NUCLEAR FUEL SERVICES, INC.

Pursuant to Paragraph 50.59 of Title 10 Code of Federal Regulations, Nuclear Fuel Services, Inc. hereby requests a change in Technical Specifications for Operating License CSF-1. The proposed changes will permit the NFS Processing Plant at West Valley, New York to transfer to process and process plutonium nitrate-uranyl nitrate solutions such as now being prepared at the NFS facility at Erwin, Tennessee. The Division of Material Licensing previously approved receipt and storage of such material by Change No. 14 of the Technical Specifications of License CSF-1. The safety evaluation of the proposed processing plan and the proposed changes to the Technical Specifications are attached.

SAFETY EVALUATION
TRANSFER AND PROCESSING OF PLUTONIUM
NITRATE-URANYL NITRATE SOLUTIONS

MOTIVE PRESSURE vs DILUTION FACTORS

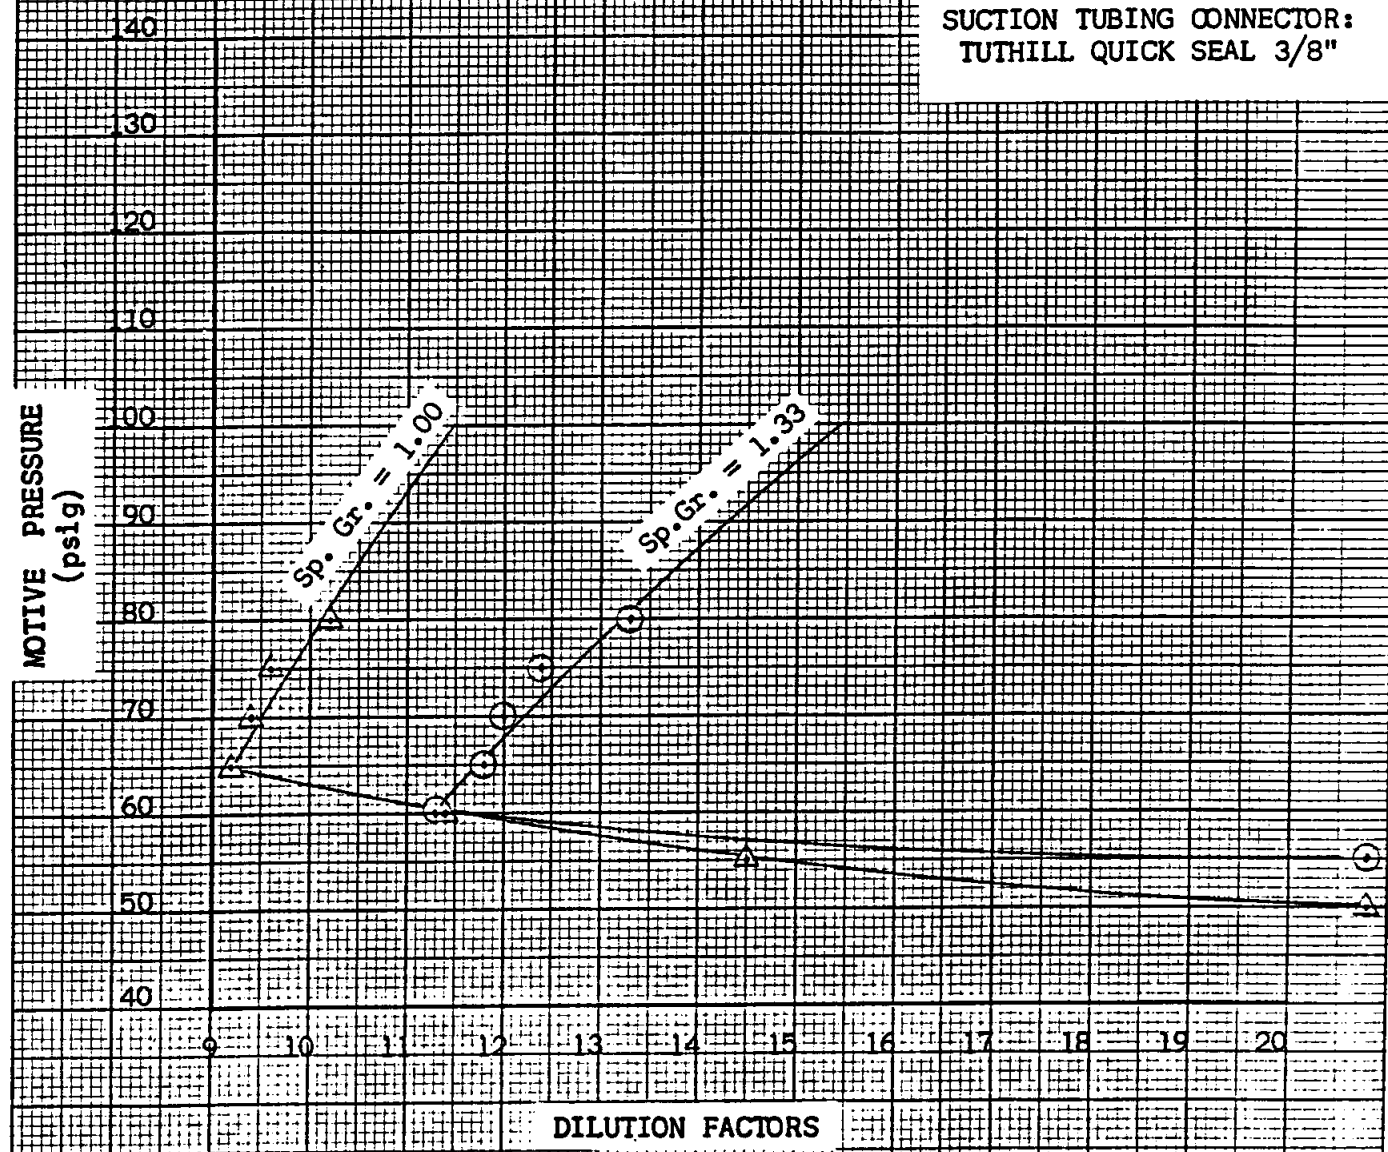
ACID MOTIVE JET (5H-41)
DISCHARGE HEAD: 30 psig
(69 ft H₂O)
SUCTION TUBING CONNECTOR:
TUTHILL QUICK SEAL 3/8"

TYPICAL PLAN VIEW
DISSOLVER BASKET BARREL

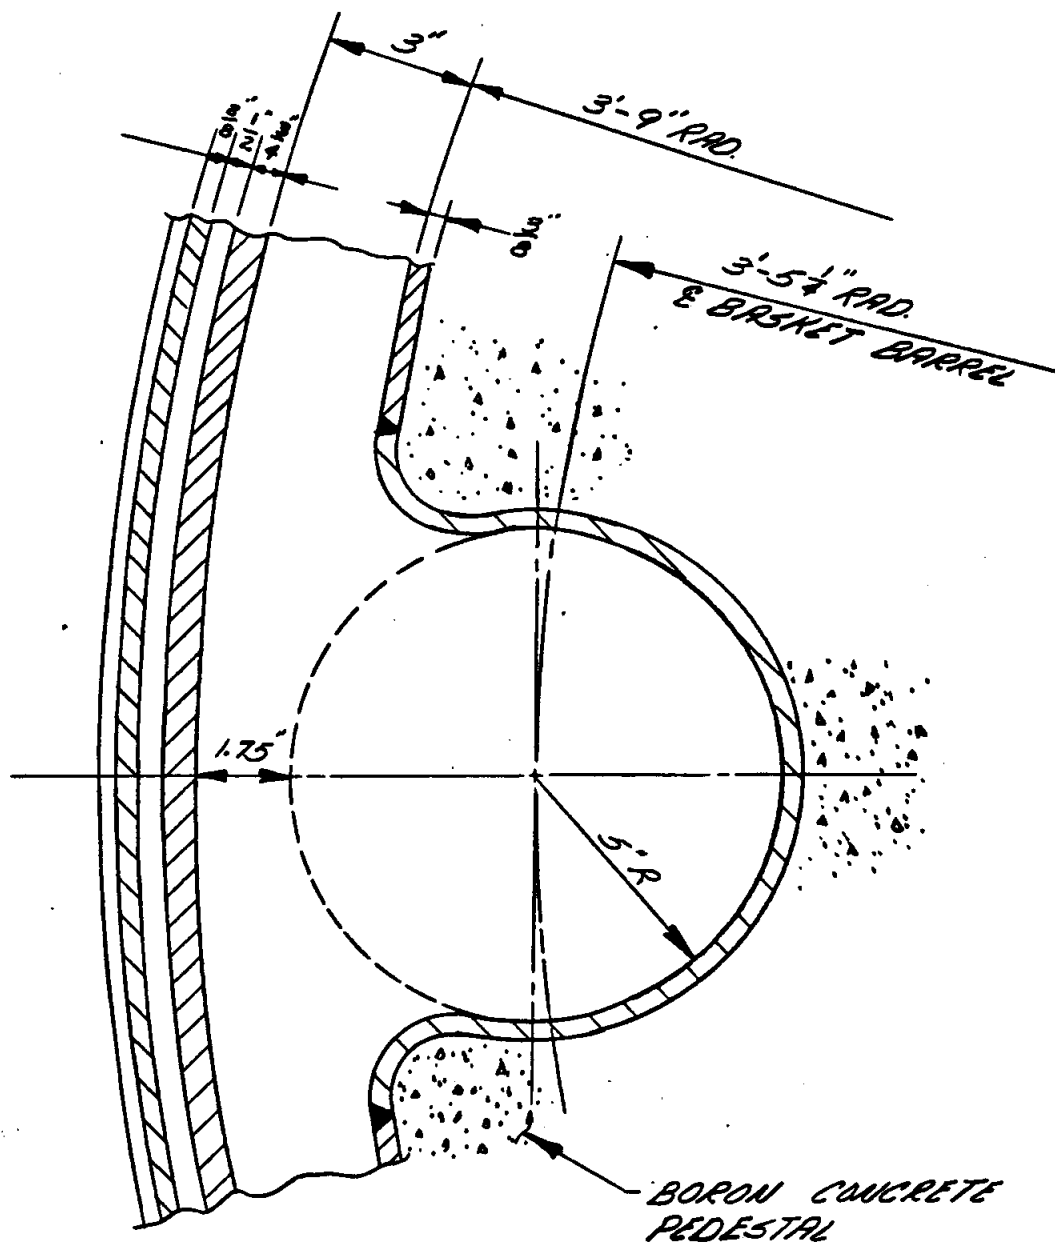
The dissolver barrels have a 10-inch diameter but, as shown on the attached plan view of a dissolver barrel, the effective diameter is somewhat larger due to the 3-inch annulus. Using the longest diameter of 17 inches, assuming symmetry which does not exist and neglecting the neutron absorption in both the uranium and the nitric acid, the minimum critical concentration computed from ARH-600 for an infinite cylinder is

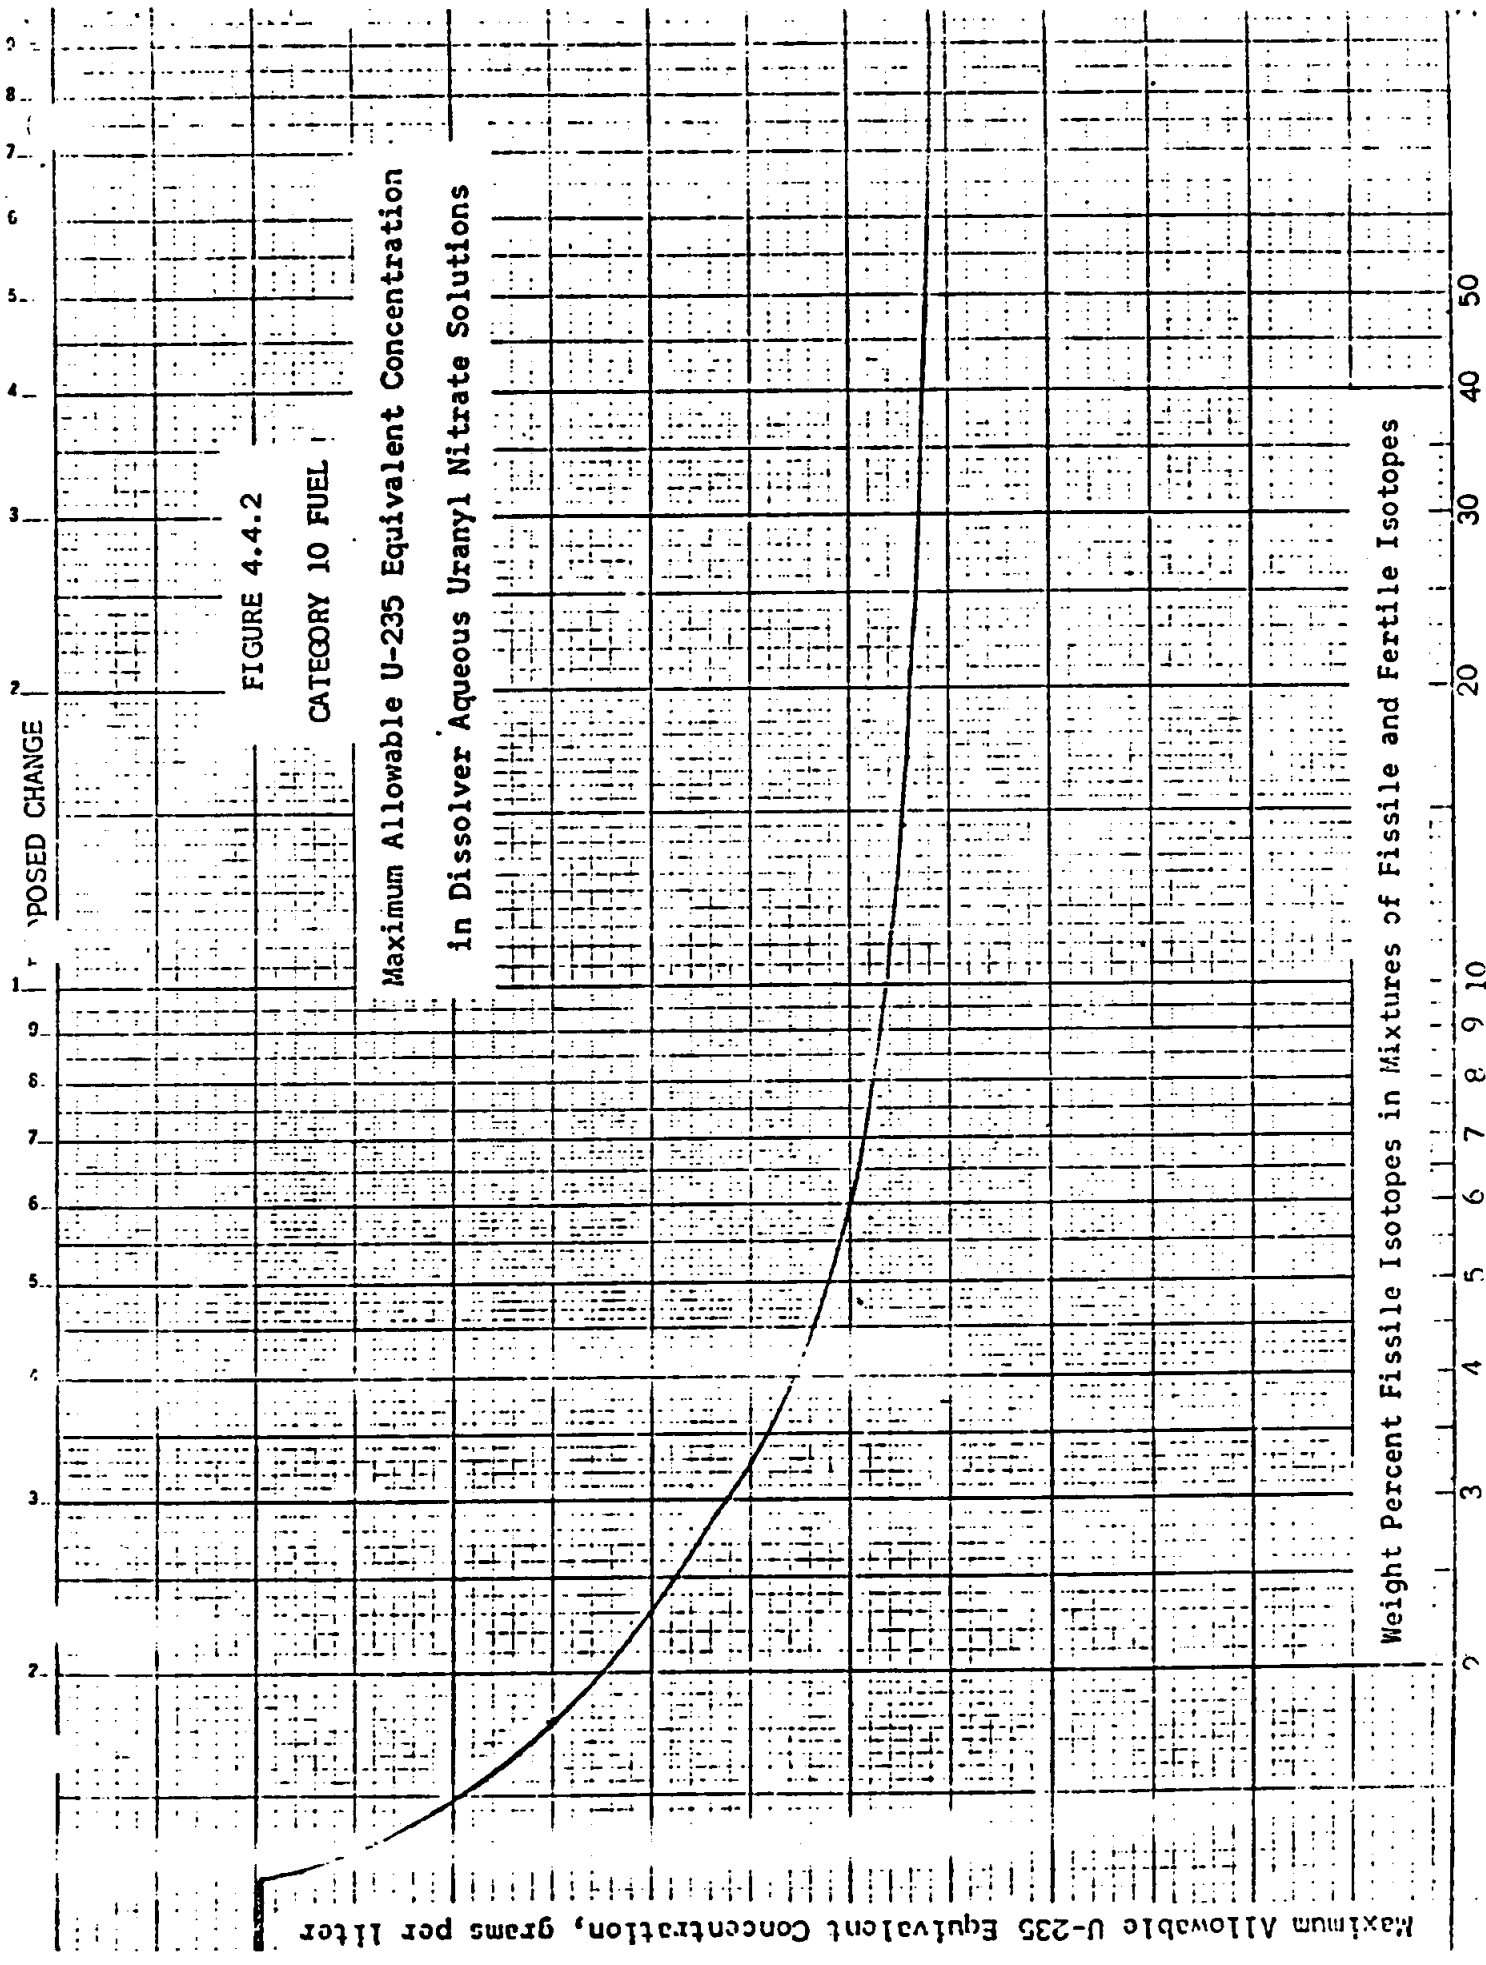
4.4.4 FOR CATEGORY 10 FUELS, TRANSFERS TO THE DISSOLVERS SHALL BE CONTROLLED SO THAT THE RESULTANT U-235 EQUIVALENT CONCENTRATION IN A DISSOLVER SHALL NOT EXCEED THE CONCENTRATIONS SHOWN IN FIGURE 4.4.2.

Specification 4.4.4 was added to control and authorize the processing of Category 10 fuel in the dissolver. The concentration of Category 10 fuel shall not exceed the concentration shown in new figure 4.4.2. The criticality safety of the of the dissolver is provided by controlling the fissile isotope concentration. The concentrations specified in Figure 4.4.2 are 60% of the calculated critical concentrations reported in ORNL-TM-686 Limiting Critical Concentrations of Aqueous Nitrate Solutions of Fissile and Fertile Isotopes.

mixtures of fissile and fertile isotopes. The concentrations specified in Figure 4.4.2 are 60% of the calculated critical concentrations reported in ORNL-TM-686, Limiting Critical Concentrations of Aqueous Nitrate Solutions of Fissile and Fertile Isotopes.

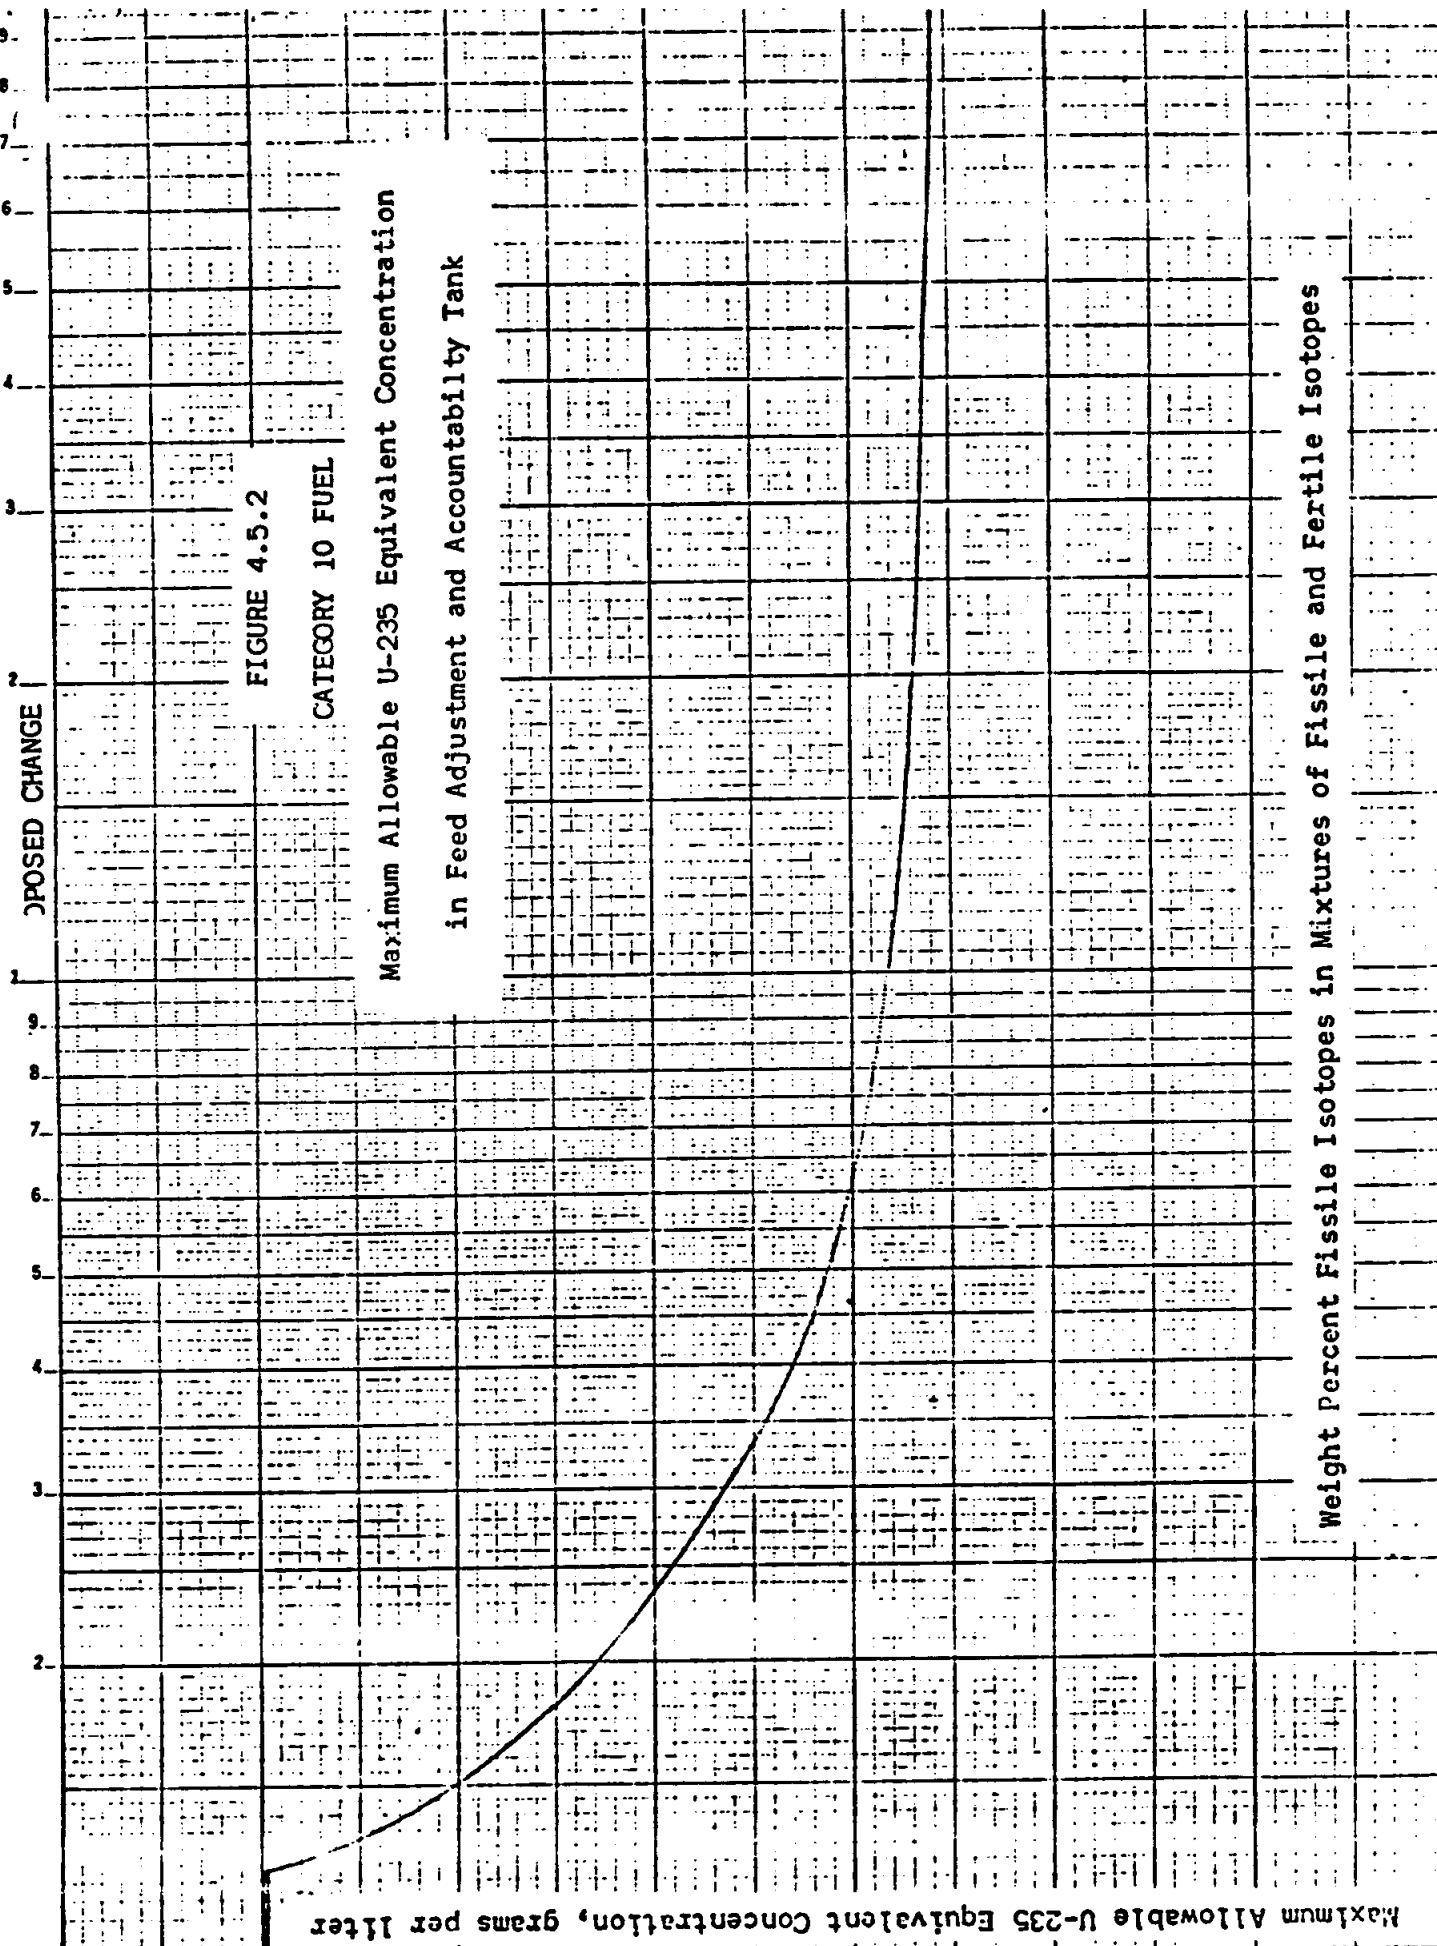
4.5.3 FOR CATEGORY 10 FUELS THE CONCENTRATION OF FISSILE ISOTOPES IN THE FEED ADJUSTMENT AND ACCOUNTABILITY TANK SHALL NOT EXCEED, AFTER ADJUSTMENT, THE U-235 EQUIVALENT CONCENTRATION SHOWN IN FIGURE 4.5.2 BASED UPON ANALYSIS PRIOR TO ADJUSTMENT.

Specification 4.5.3 was added to control and authorize the processing of Category 10 fuel in the Feed Adjustment and Accountability Tank. In like manner to the change in Technical Specification 4.4 a new Figure 4.5.2 has been added to Technical Specification 4.5.

For Category 10 fuel the concentrations of solutions in the dissolver must be controlled to values that are safe for fissile isotopes in mixtures of fissile and fertile isotopes. The concentrations specified in Figure 4.5.2 are 60% of the calculated critical concentrations reported in ORNL-TM-686, Limiting Critical Concentrations of Aqueous Nitrate Solutions of Fissile and Fertile Isotopes.
